Access Compliance Report

Public Rights-of-Way

(Curb Ramps)

Intersection ID: 10029243	Main Street: JOHNSTON_RD	Cross Street: N/A	Location: SW
ADA ID: B72FD2044CF6	Ramp Type: BlendTrans1	Initial Pass/Fail: Pass	Overall Compliance: No
		Severity Score: 0.25

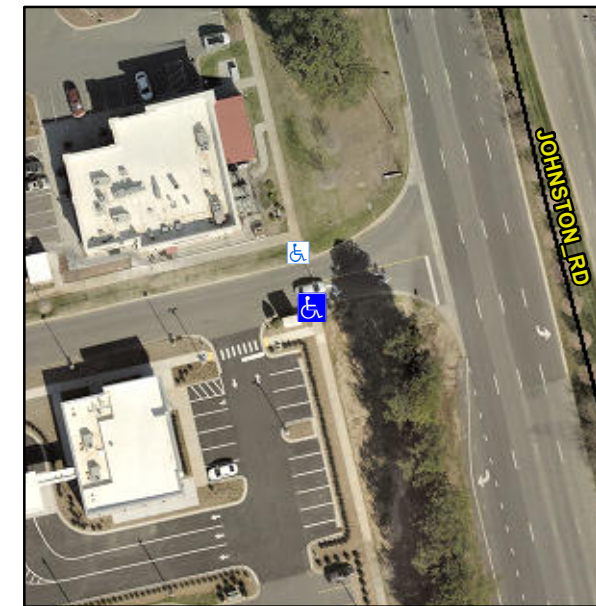
Not Found, R304.5.3, R304.2.1

Compliance	Description	Data	Compliance	Description	Data
N/A	Ramp Length (in)	57.0	Yes	BlendTrans Slope (%)	2.7
Yes	Ramp Width (in)	48.0	No	BlendTrans XSlope (%)	2.9
N/A	Flare Type LT	Sloped	N/A	Flare Type RT	Sloped
N/A	Flare Slope LT (%)	0.1	N/A	Flare Slope RT (%)	6.8
N/A	Flare Traversable LT?	No	N/A	Flare Traversable RT?	No
No	Landing Length (in)	45.0	Yes	DWS Provided?	Yes
Yes	Landing Width (in)	48.0	Yes	DWS Contrast?	Yes
Yes	Landing Slope (%)	0.4	Yes	DWS Length (in)	25.5
Yes	Landing X Slope (%)	0.7	Yes	DWS Full Width?	Yes
N/A	Landing Curb? (Y/N)	No	Yes	DWS Offset (in)	0.0
N/A	Shared Landing?	No			
Yes	Gutter Ponding?	No	Yes	Gutter Slope (%)	2.9
Yes	Gutter Lip Ht (in)	0.0	No	Gutter X Slope (%)	2.9
N/A	Painted X Walk1?	No	N/A	Painted X Walk2?	N/A
	X Walk 1 Direction	To N		X Walk 2 Direction	N/A
	X Walk 1 Width (in)	N/A		X Walk 2 Width (in)	N/A
	X Walk 1 Slope (%)	0.9		X Walk 2 Slope (%)	N/A
	X Walk 1 X Slope (%)	2.7		X Walk 2 X Slope (%)	N/A

N/A	Ramp inside XWalk1?	N/A	N/A	Ramp inside XWalk2?	N/A
	Road Slope (%)	2.7		Clear Space?	Yes
	Road X Slope (%)	0.9	N/A	Clear Space to XWalk (in)	N/A
Yes	Any Obstructions?	No	Yes	Storm Grate/Utility Hazard?	No
	Obstruction Type			Storm Grate/Utility Type	
			N/A		N/A
			Yes	Surface Condition? (G/P)	Good
			No	Curb Slope (%)	19.0

Remove & Replace Curb Ramp With Two New Directional Ramps or Equivalent. Remove & Replace Gutter.
